Assessment of Dam Safety Coal Combustion Surface Impoundments (Task 3) Final Report

Louisville Gas &
Electric Company
(A subsidiary of E.ON U.S.)

Cane Run Power Station
Louisville, Kentucky

April 16, 2010

PROJECT NO. 20085.9000
DATE: 04/2010
FIGURE 8

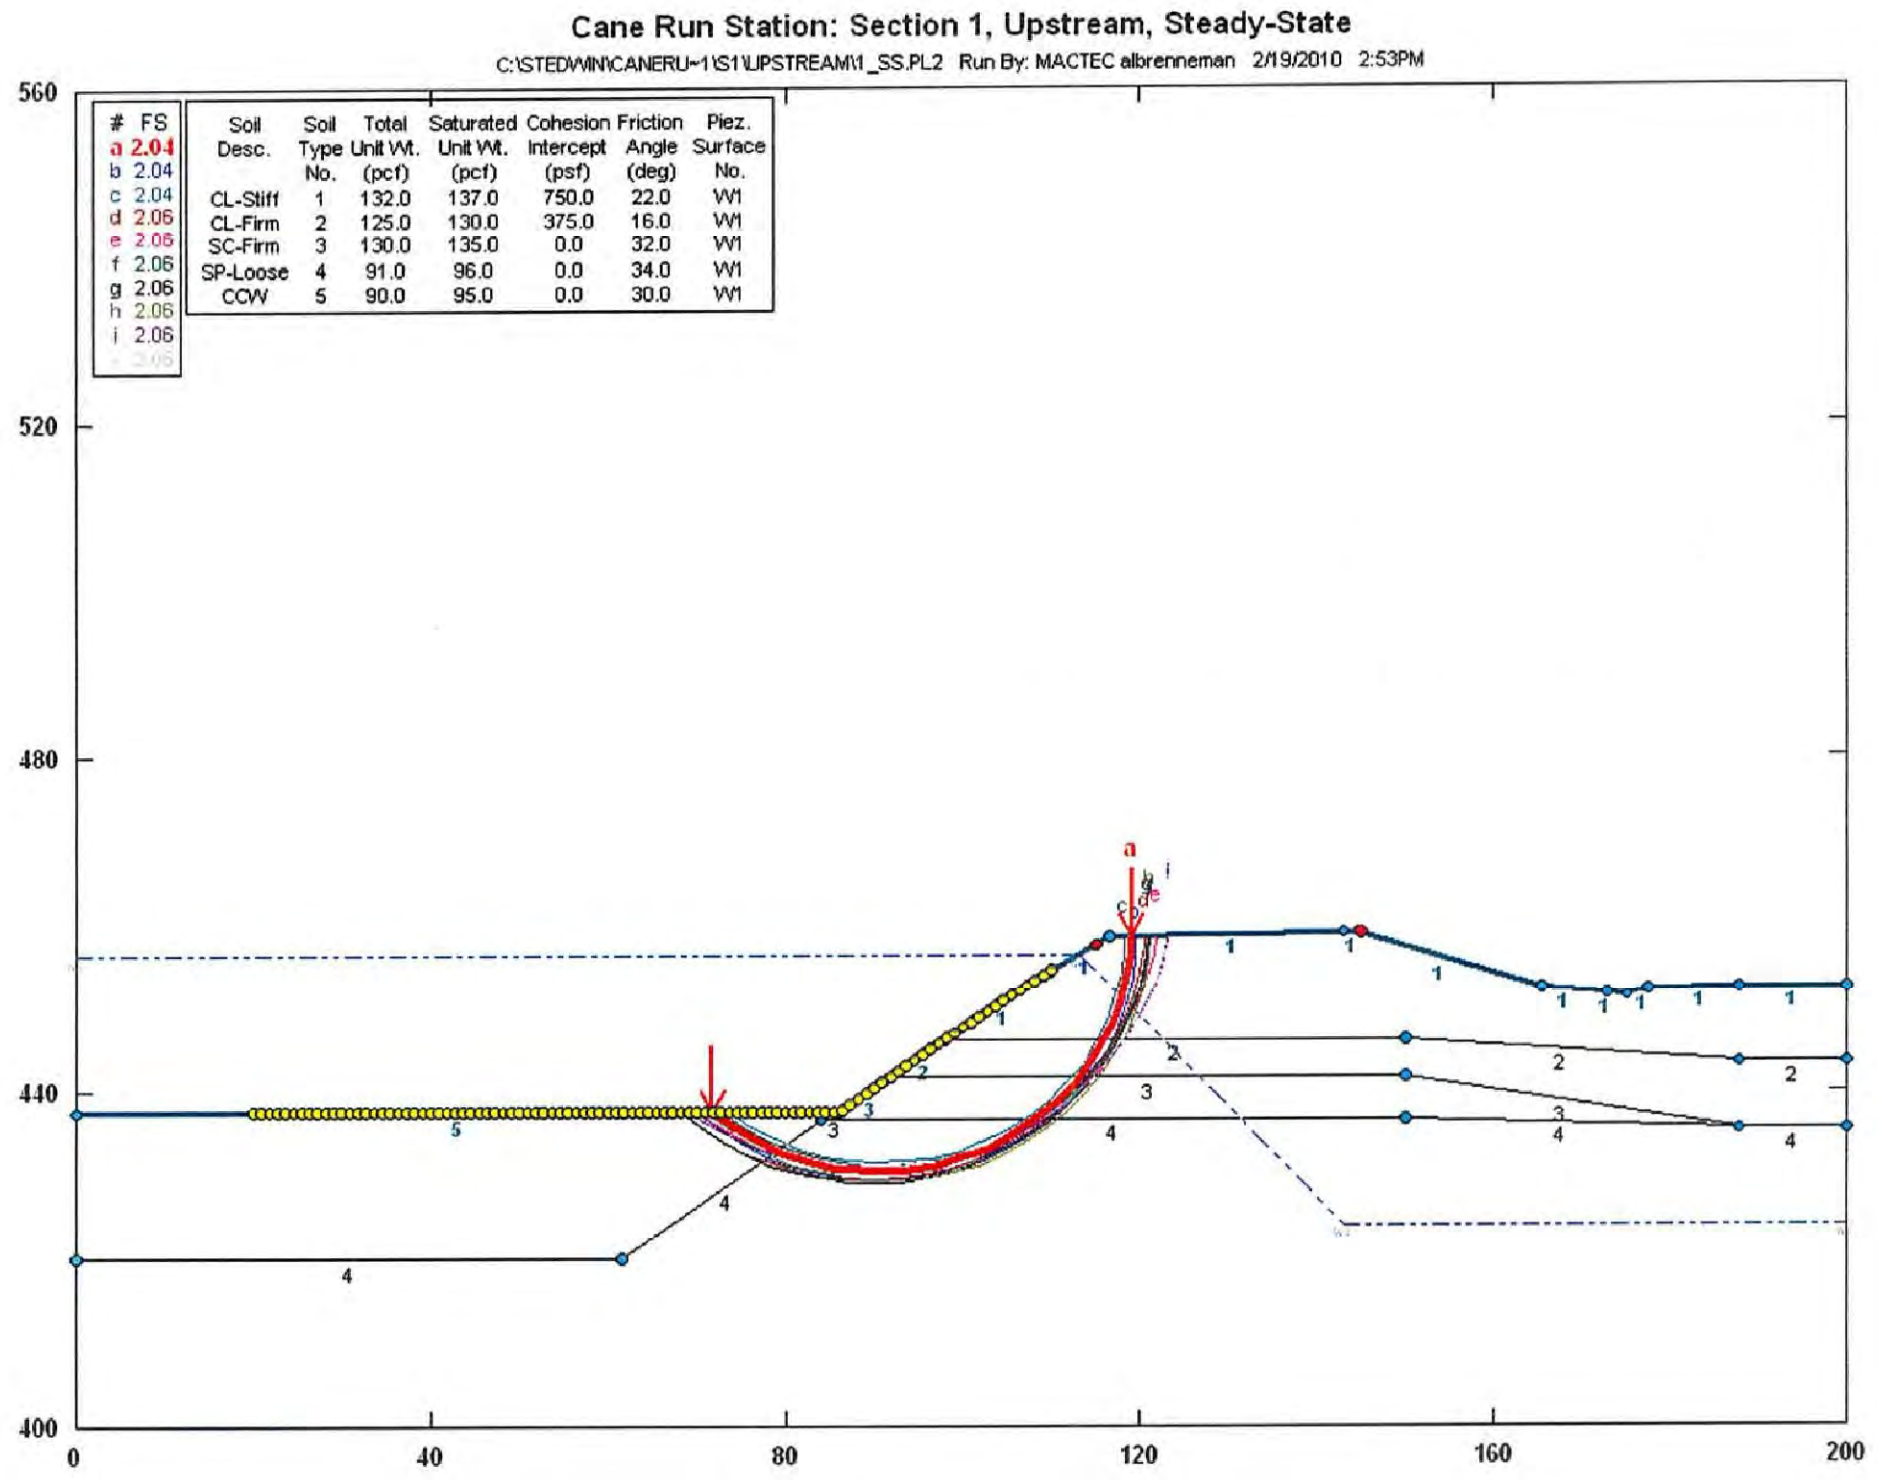
CHA has reviewed preliminary analyses for the ATB performed by MACTEC. Figure 8 shows an example cross section. MACTEC used the soil strengths as shown in Table 4 below:

All analyses shown in this table show the ATB dike is stable under the required and recommended loading conditions. MACTEC noted in their Executive Summary that at Section 1, the upstream, rapid drawdown condition factor of safety was only 1.21 (the Table presents this factor of safety as 1.3). They note that this is in the area with the least deposited ash (near the discharge structure), and that if ash were to be dredged from this area, the loss of buttressing from the deposited ash would likely result in a factor of safety below the required value. MACTEC indicates that in their final report a critical ash elevation will be established to maintain adequate factors of safety under all loading conditions.

STABL6H FSmin=2.04
Safety Factors Are Calculated By The Modified Bishop Method

- Update the ATB Operation and Maintenance Plan with maximum dredge elevations where the "buttress" effect of deposited fly ash on the upstream slope is a key component of maintaining adequate factors of safety under all loading conditions.
- Evaluate the potential impact of soft clay/CCW fill that appeared to be in place below portions of the Dead Storage/Basin Pond Dike.
